HISTORIC AND DESIGN REVIEW COMMISSION

HDRC CASE NO: 2021-090

ADDRESS: 310 E CAROLINA ST **LEGAL DESCRIPTION:** NCB 2956 BLK 0 LOT 17

TYPE OF WORK: Demolition of primary structure, new construction of primary structure and

Sheet Name
Existing Floor Plan + Photos

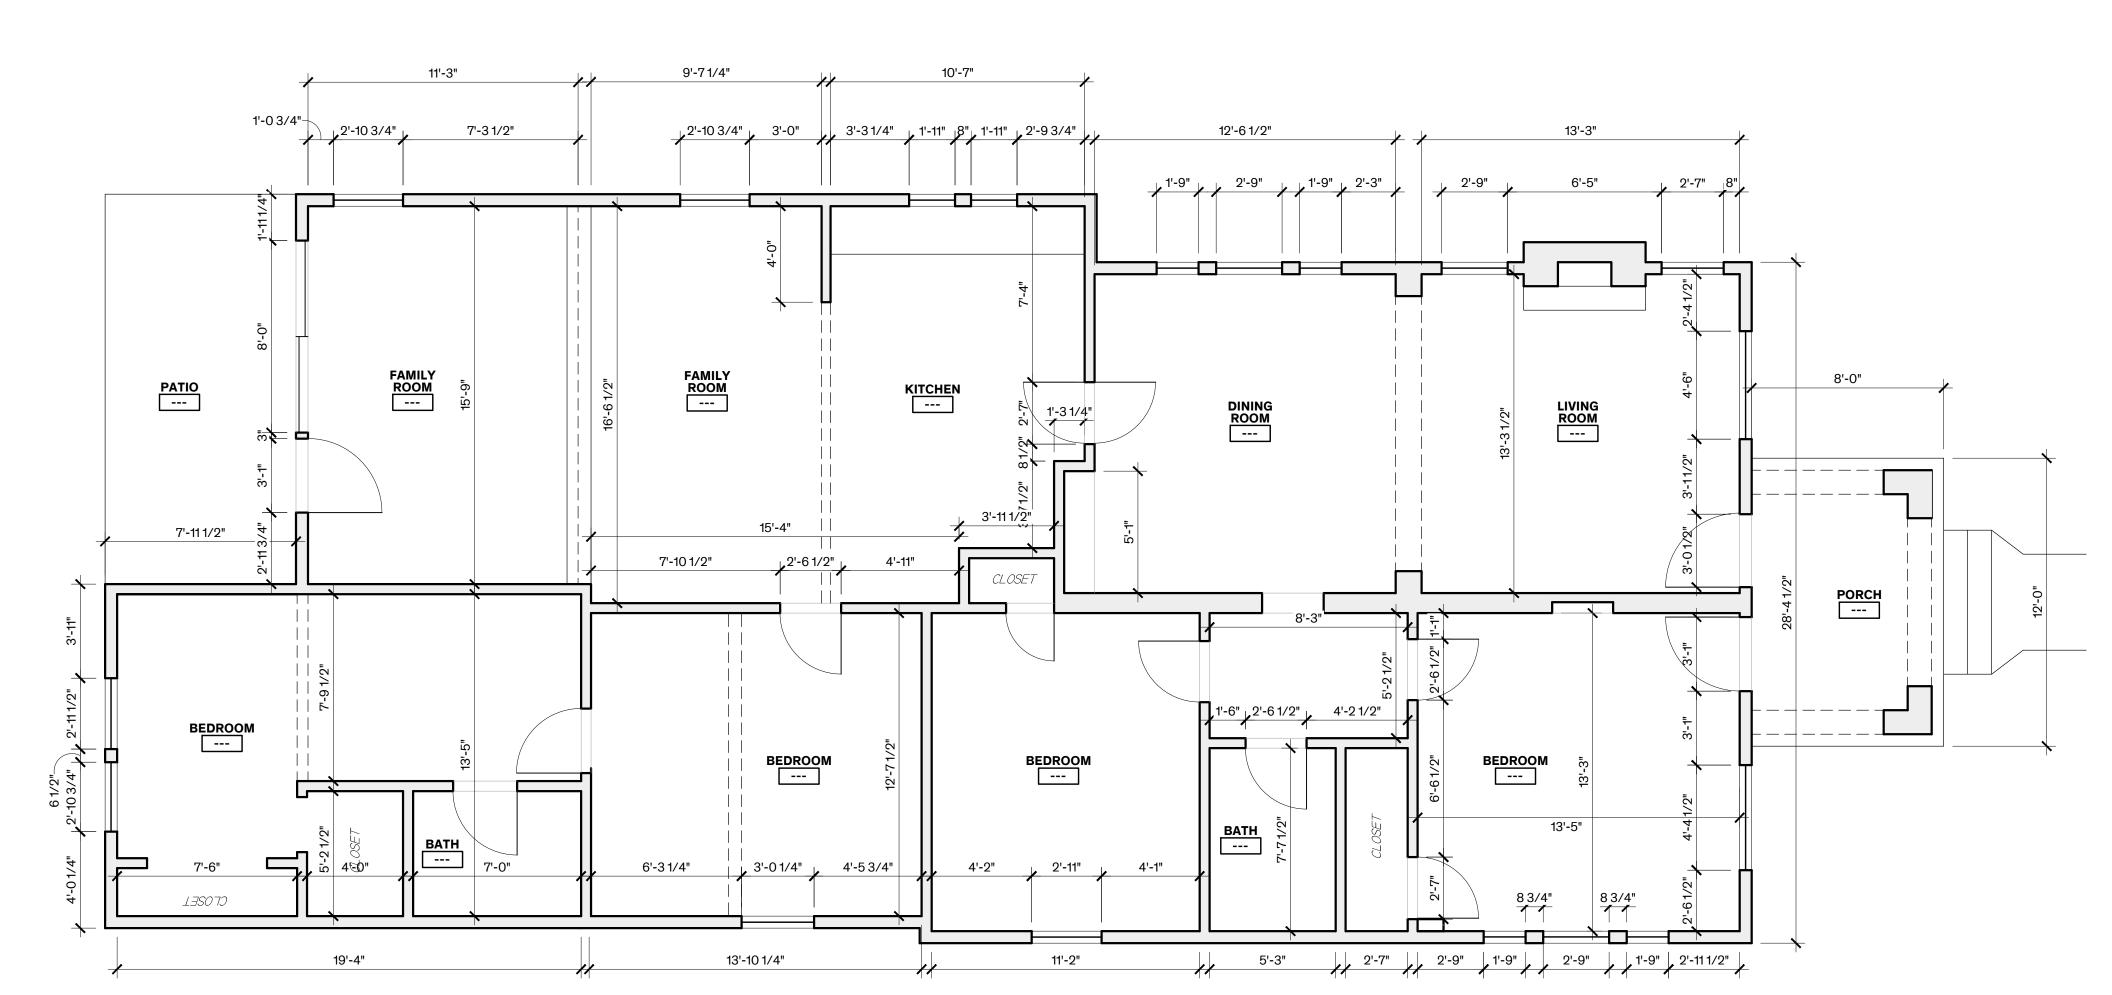
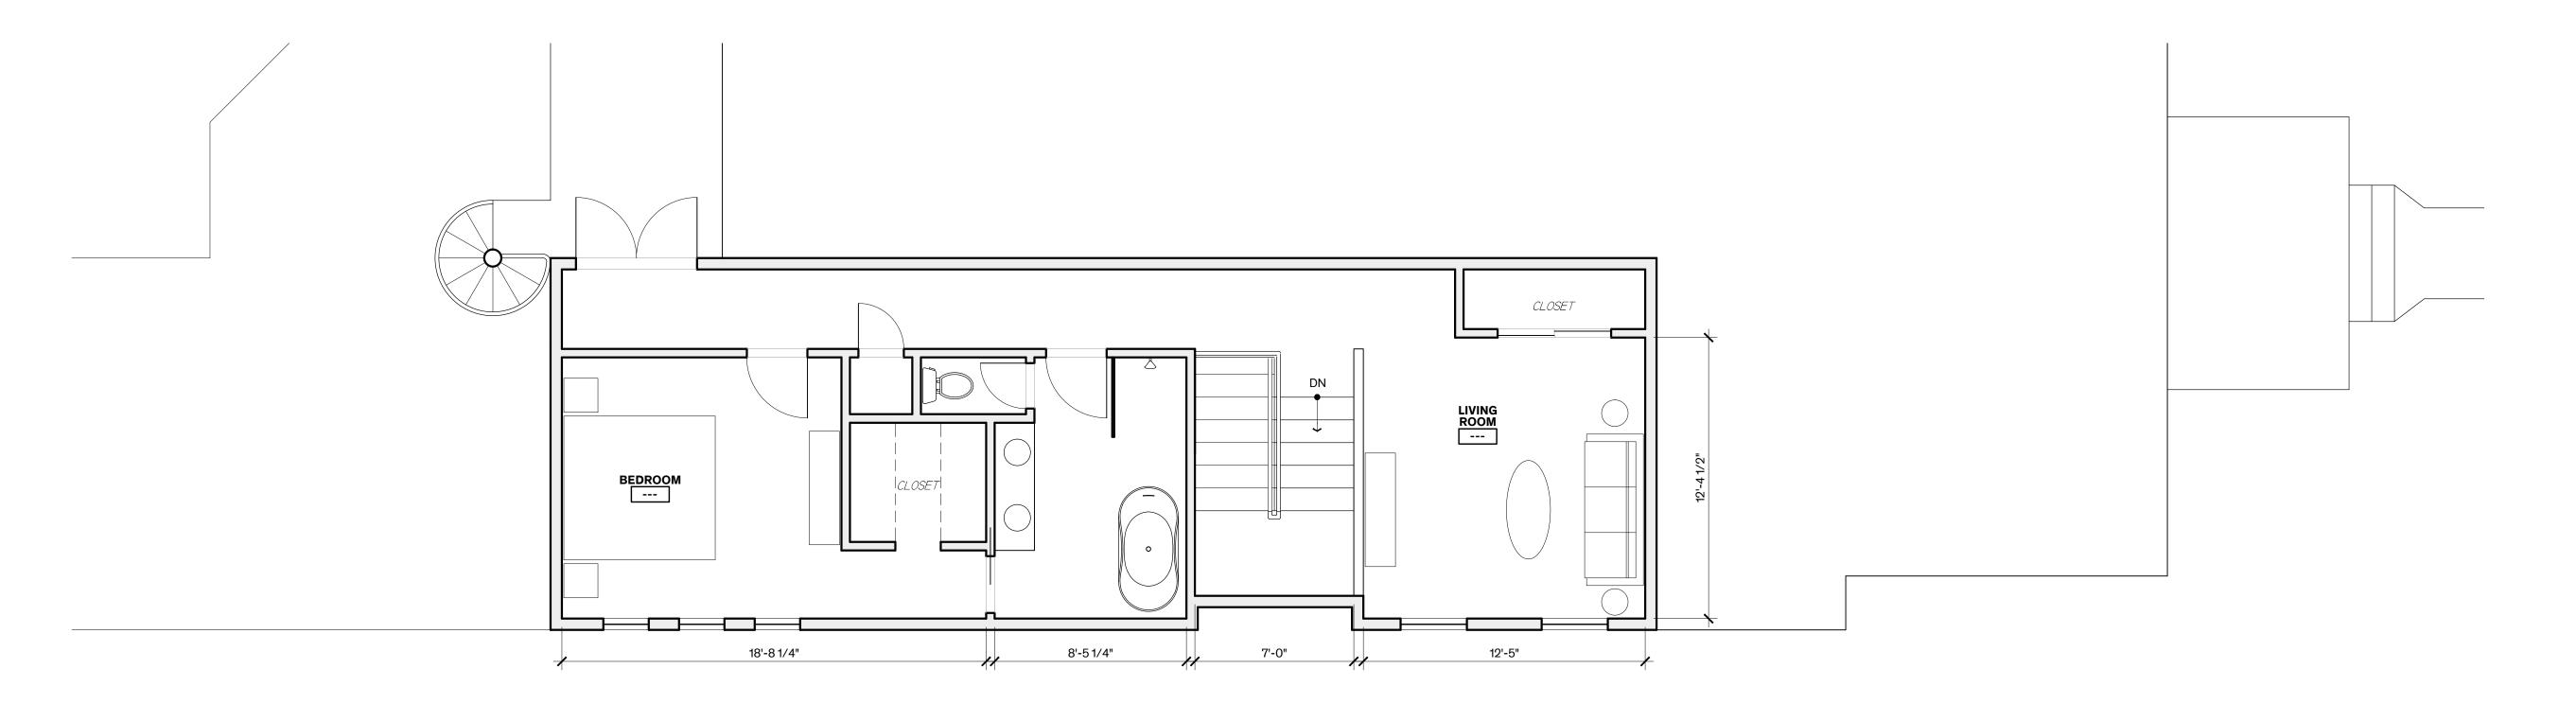
- b. DESIGN REVIEW COMMITTEE The applicant attended a Design Review Committee (DRC) meeting on March 24, 2021. The discussion focused on clarifying the scope of the demolition request, the materiality of the primary structure and current conditions, the overall square footage and design of the addition, the visibility of the rear addition from the public right-of-way, the setback of the rear addition from the neighboring property, and the fenestration pattern. The applicant attended a DRC site visit on March 30, 2021. The DRC site visit focused on determining the terminus of the tile construction and establishing the portions of the structure that are original and those that are later additions.

- 2b. RECONSTRUCTION OF PRIMARY STRUCTURE The applicant has proposed to reconstruct the primary structure to match existing. The reconstructed primary structure will feature wood frame construction, a single front entrance, as opposed to the existing double entry, a standing seam metal roof, stucco cladding, and one-over-one aluminum clad wood windows. Staff finds the proposal to reconstruct the primary structure to match existing in footprint, materials, and form appropriate.

- i. That the applicant submits accurate, as-built elevation drawings for each side of the existing structure and proposed addition to staff for review prior to returning to the HDRC for conceptual approval.

Floor Plan - Option 2

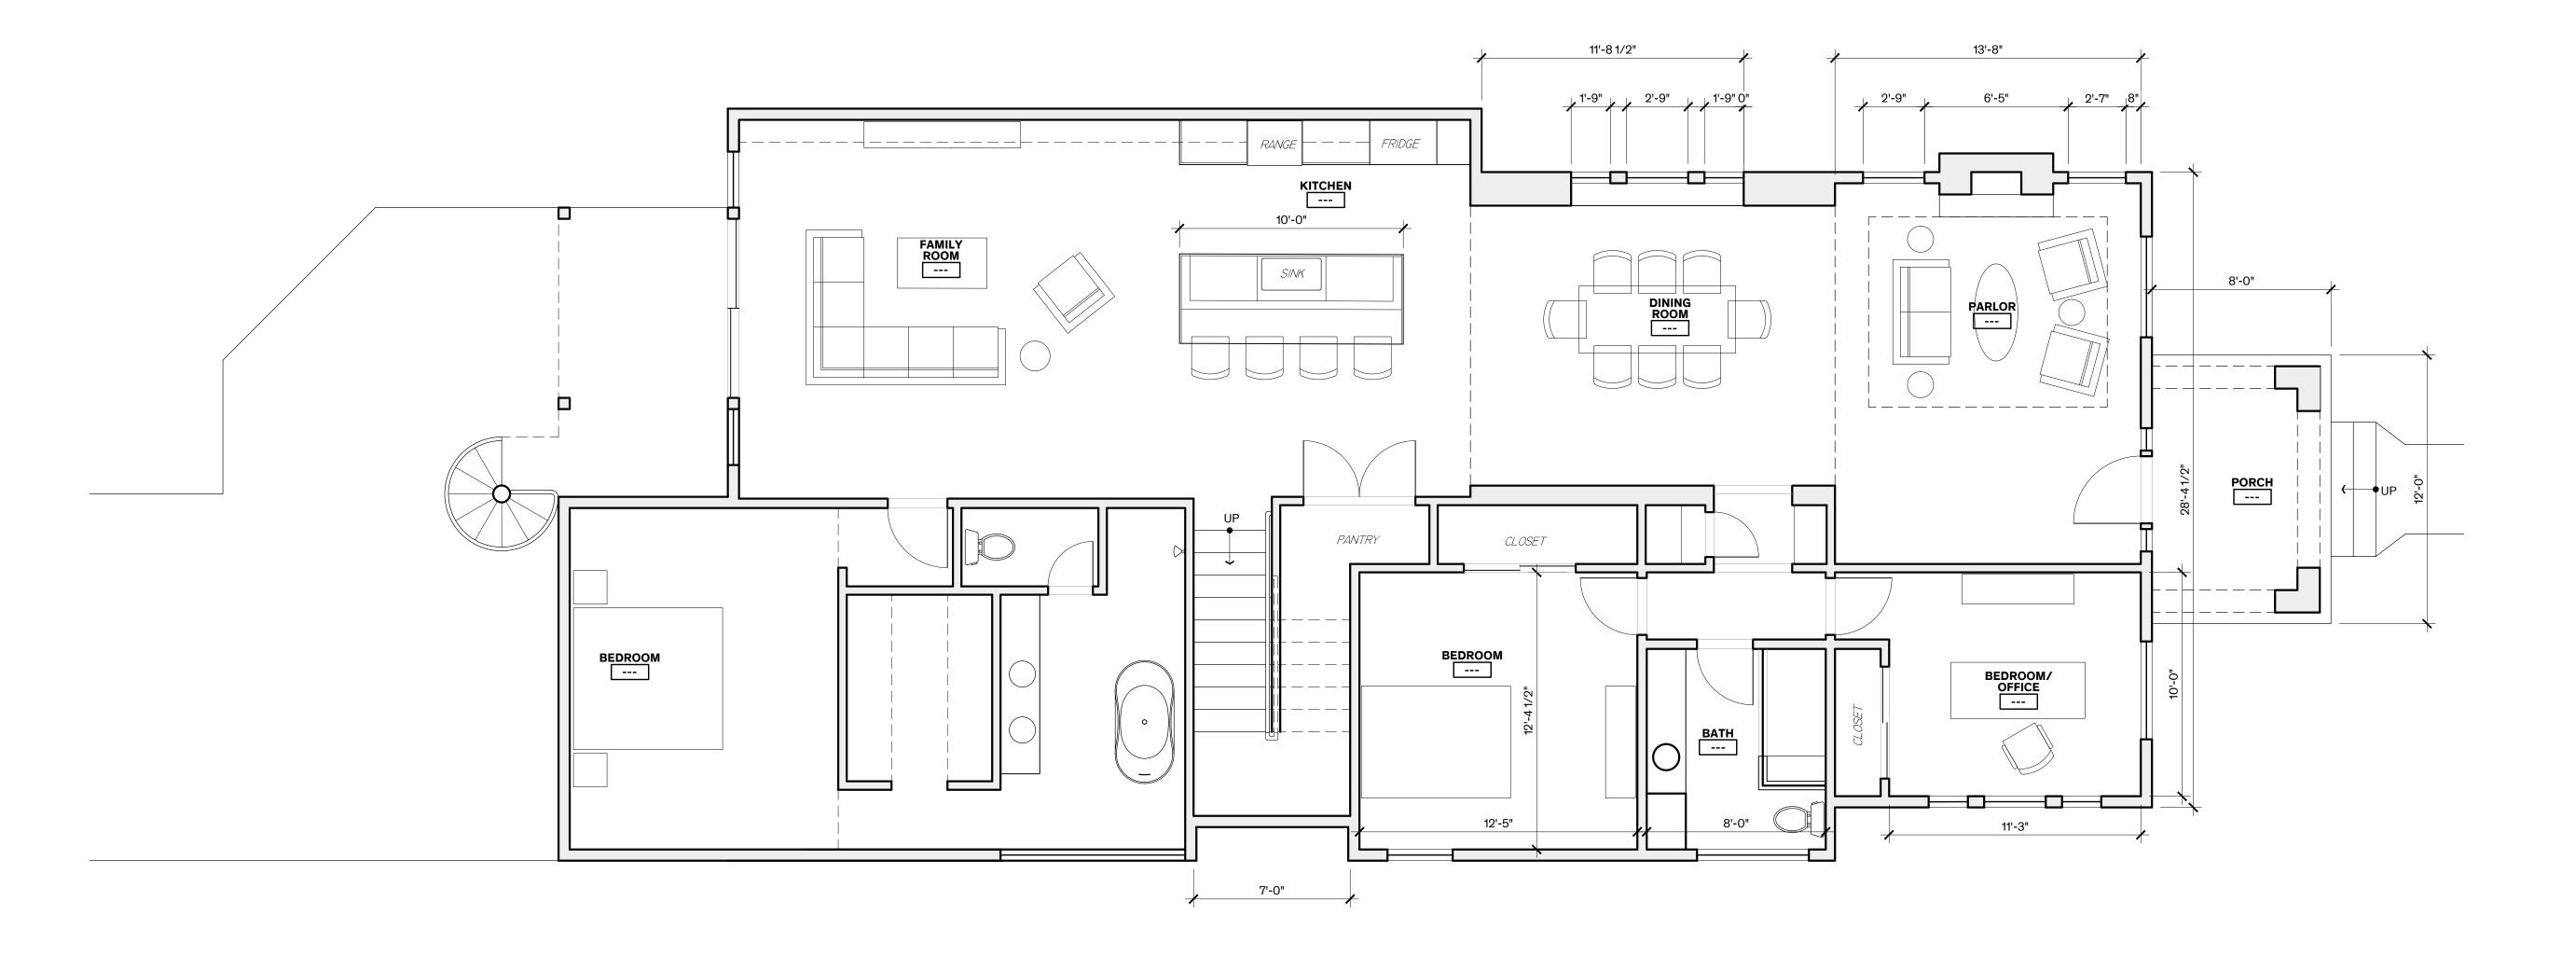
- 2c. LOT COVERAGE The applicant has proposed to construct a 2-story rear addition to the reconstructed primary structure. The applicant has not provided total square footage of the primary structure and the addition. The applicant should submit the total square footage and percentage of lot coverage for review. Total lot coverage should not exceed 50 percent.

- 2d. MASSING AND FOOTPRINT The applicant has proposed to construct a 2-story rear addition. Guideline 1.B.i for Additions stipulates that residential additions should be designed to be subordinate to the principle façade of the original structure in terms of scale and mass. Guideline 2.B.iv for Additions states that the building footprint should respond to the size of the lot. An appropriate yard to building ratio should be maintained for consistency within historic districts. Residential additions should not be so large as to double the existing building footprint, regardless of lot size. The proposed addition is 2-stories, which is a full story larger than the primary historic structure. The floor heights of the rear addition allow for the view from the public right-of-way is minimized. The existing structure is approximately 1,938 square feet. The proposed reconstructed structure with the new 2-story rear addition will be approximately 2,214 square feet. The footprint of the original clay tile structure is approximately 885 square feet. Staff finds the proposal appropriate.

- 2e. ROOF The applicant has proposed to install a front gable roof form on the 2-story rear addition that will be visible from the public right-of-way. The side of the rear addition facing west will feature a shed roof and second floor balcony at the rear. Only a portion of the front gable roof on the rear addition will be visible from the public right-of-way, over the east side of the front facade. Guideline 1.A.iii for Additions stipulates that residential additions should utilize a similar roof pitch, form, overhang, and orientation as the historic structure. The historic structure features a side gable roof form with a front gable. Staff finds that the applicant should submit a line-of-sight study for review.

- iii. That the applicant provides percentage of lot coverage and total square footage for the existing structure and the proposed addition prior to returning to the HDRC for conceptual approval.
